DRAINAGE LETTER REPORT

COVERTEC WAREHOUSE BUILDINGS LOT 24 & 25, CLAREMONT BUSINESS PARK FILING NO. 2

JPS Project No. 051704

PPR-17-036

Design Procedure Form: Rain Garden (RG)

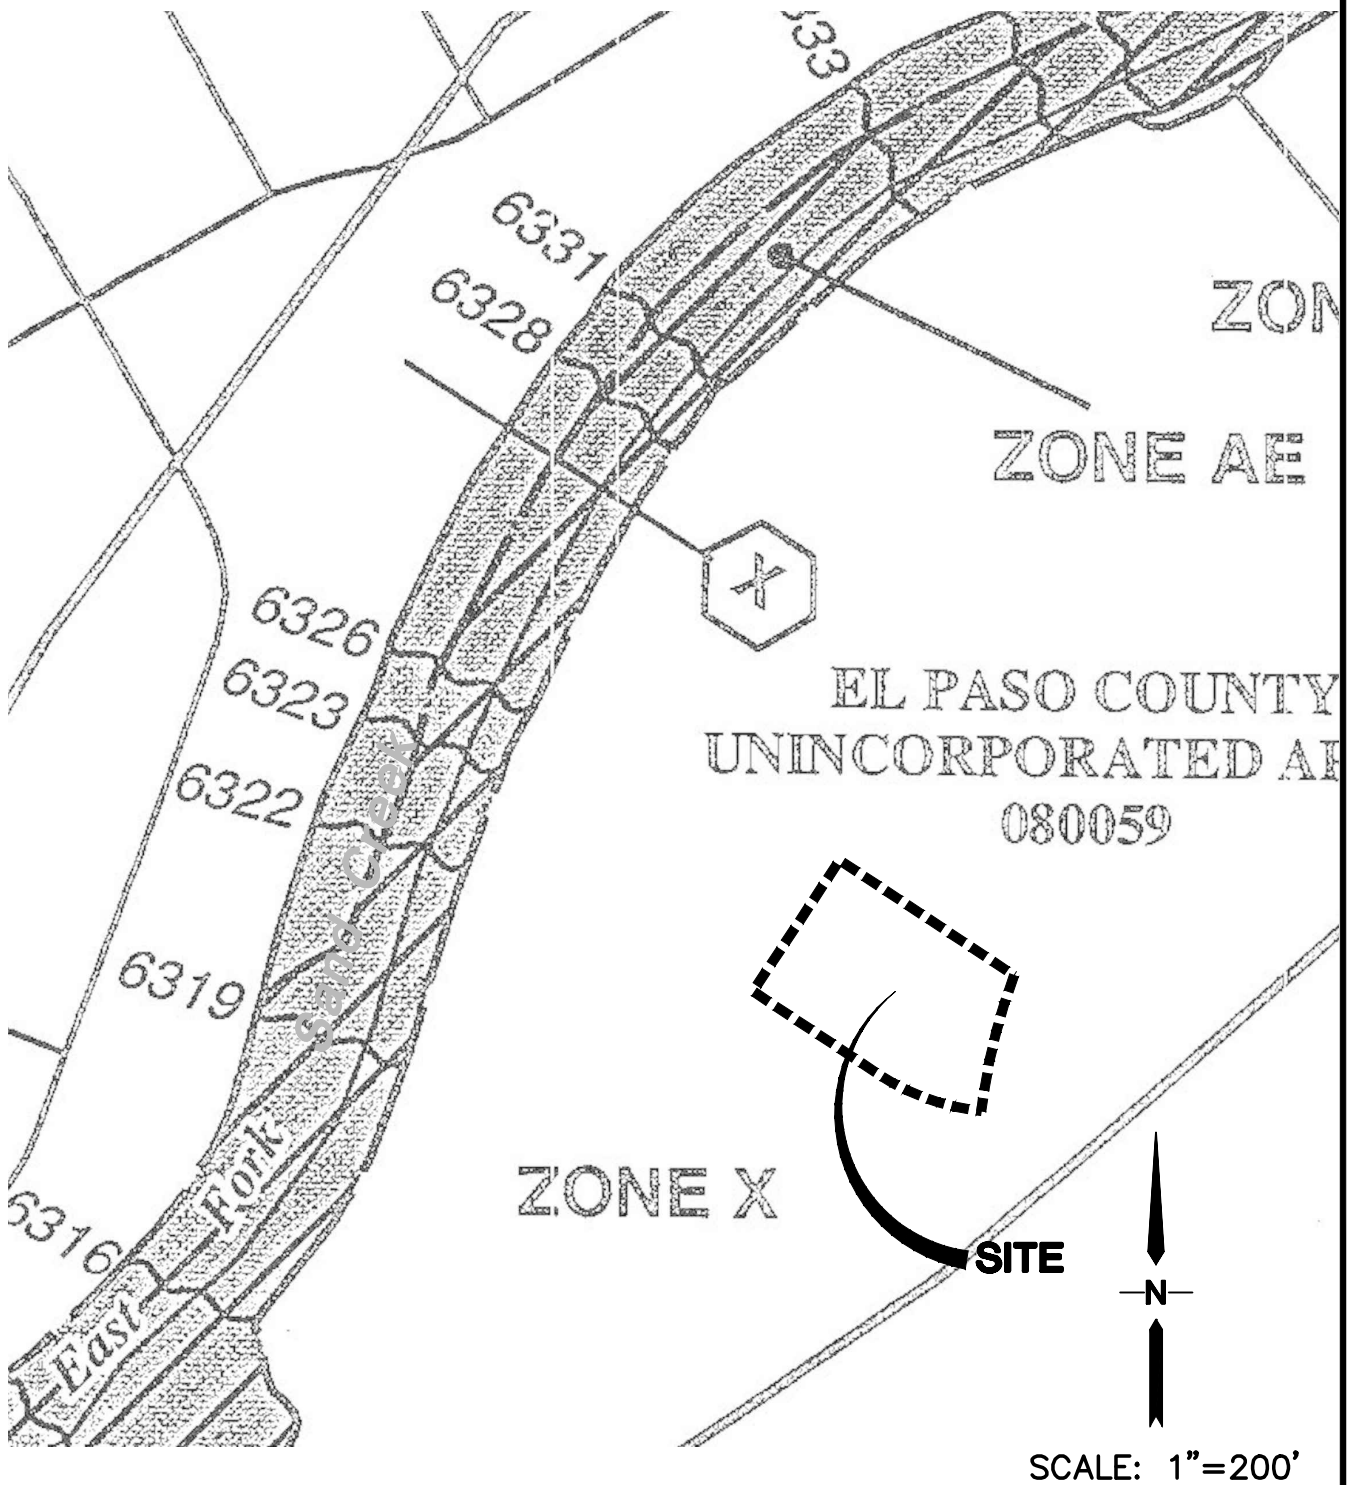
Please answer yes or no.
